Office Action Summary

10/693,699

KHALILI, FARID BRUCE

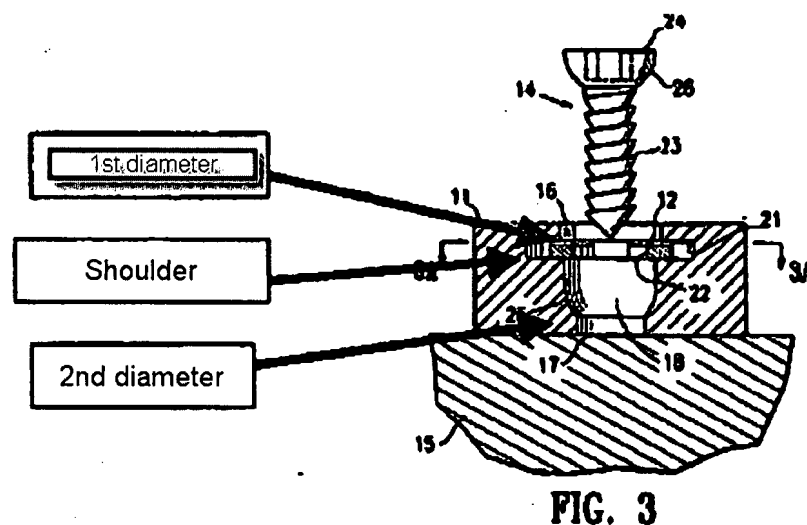
Claims 58-63 are rejected under 35 U.S.C. 103(a) as being unpatentable over Talaber et al. (US Patent 6,261,291) in view of Warden et al. (US Patent 5,261,910) and Bono (US Patent 5,954,722). Talaber et al. disclose an orthopedic implant assembly comprising a screw retention member (11) having a bore formed therethrough (13) with a first and second diameters (see drawing below).

Talaber et al. also disclose a tapered retention seat (34) along an intermediate portion of the passageway, a split ring (22) that has inside and outdoor diameters that allows for expansion, that is also removably seated in the retention seat (21) that is capable of rotating engagement with the fastener (14) and being moved by the rotation of the fastener. Talaber et al. also disclose a fastener with a shaft (proximate to 23) and a head at one end, the head being generally spherical, and wherein the shaft is threaded for purchase of bone.
